OHIO DEPARTMENT OF TRANSPORTATION

Commented [AH4]: Addendum 004

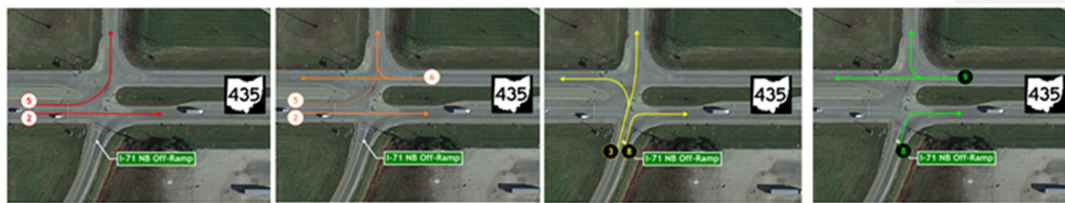
The DBT shall design the SR-435/I-71 NB Ramps signal to be ran with the phasing shown in the below graphic:
